Service Bulletin

no. 14, 2008-04-08

Non-return valves for protection of air distributor

System applicability: Marinfloc CD units

Picture 1.
Non-return valve ¼" (no. 137)
Article no. 16101

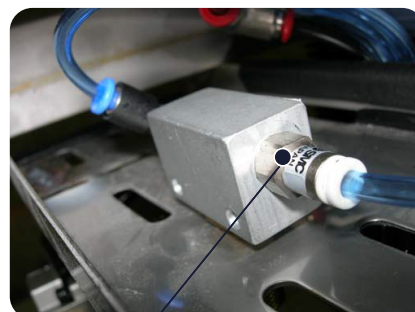
We have experienced damages to the air distributor in the electric cabinet caused by water penetration on some vessels. This has been caused by leakage of the non-return valve no. 137 on the circulation tank no. 52, see picture no. 1.

In order to avoid and correct this problem, Marinfloc recommends that the non-return valve is checked for leakage and replaced if necessary. Marinfloc also recommends that an extra non-return valve is added to the hose after the air adjustment valve no. 136 for extra safety, see picture no. 2.
